SCHOOMBEE RESIDENCE 3 RATCLIFF VIEW OCEAN BEACH

SCHEDULE OF SUBMISSIONS: SINGLE HOUSE – NO.3 (LOT 214) RATCLIFF VIEW, OCEAN BEACH (2018/110; A5357)

Re: Lot 214, 3 Ratcliff View, Ocean Beach

Date: JUNE 2018
 Drwg: WD 1A

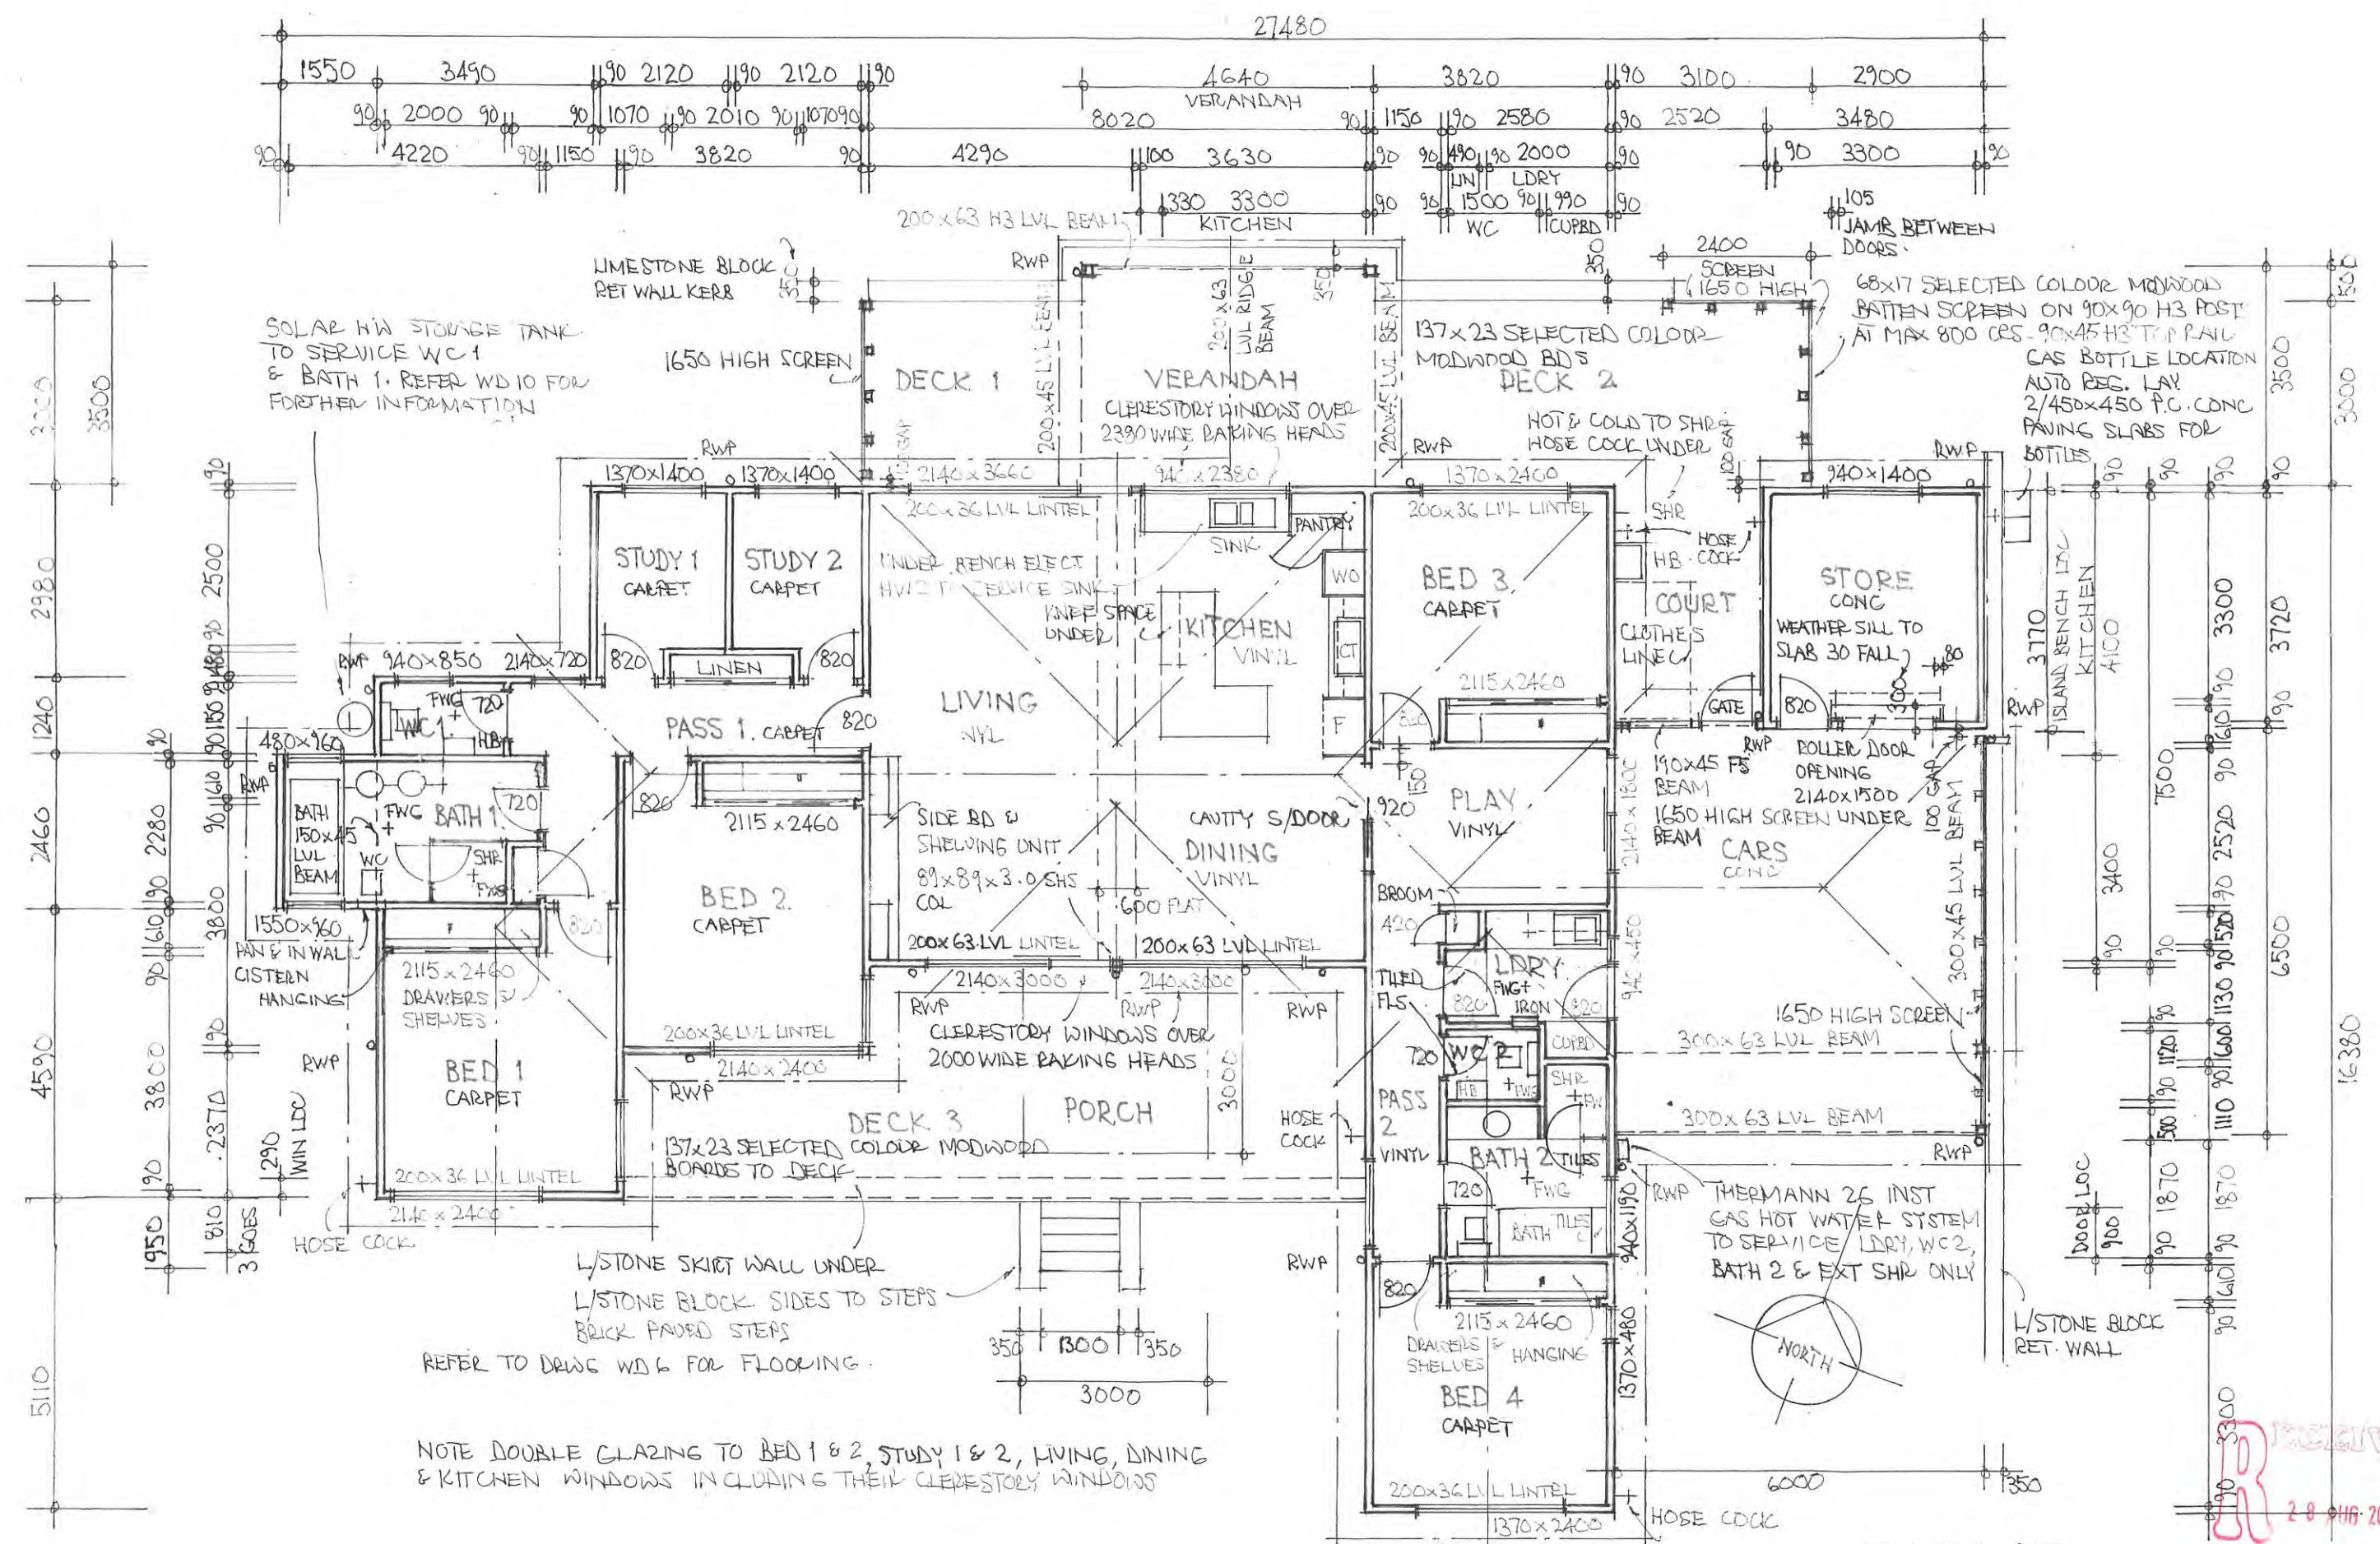
Apart from the reduction of the rear setback, the other objection by the neighbour relates to the windows of each study which were in breach of the visual privacy setback requirements of the R-codes. After reducing the sizes of the studies, the window of study 2 no longer breaches the visual privacy requirements. The window of study 1 still breaches the requirements, but very minimally in relation to lot 209. Further, the position of the proposed building on lot 209 (the drawings of which were provided to us, because it breached the R-codes and required a waiver which was granted by Council to the owners of lot 209) indicates that the north eastern corner of their lot, which is impacted by the visual cone, is unlikely to be used for any outdoor living space.

There is also a breach of the visual privacy setback requirements of the R-codes occasioned by our deck at the rear of the house. However, the drawings have already included a screen on the western side of the deck which blocks any view onto lot 209. The only visual impact cone from the deck affects lot 208, but we note that there has been no objection to any breach of the visual privacy requirements in relation to the deck. We are not aware of the proposed positioning of the building on lot 208, but a building on that lot is also likely to be substantially removed from our western boundary to maximise the views from that lot. Accordingly, the visual cone protrusion is not likely to impact on the outdoor living space of the neighbours on lot 208 either. We attach a drawing B which shows the position of the proposed building on lot 209 in relation to our proposed revised building and the limited extent of the visual impact cones on both lots 209 and 208.

Nevertheless, in order to comply with the visual privacy setback requirements, we are prepared to put up screens to block the visual cone from study 1 impacting on lot 209 and the visual cone from the deck impacting on lot 208. The proposed screens which are in accordance with the requirements of the R-codes have been indicated on the attached drawing WD 1A.
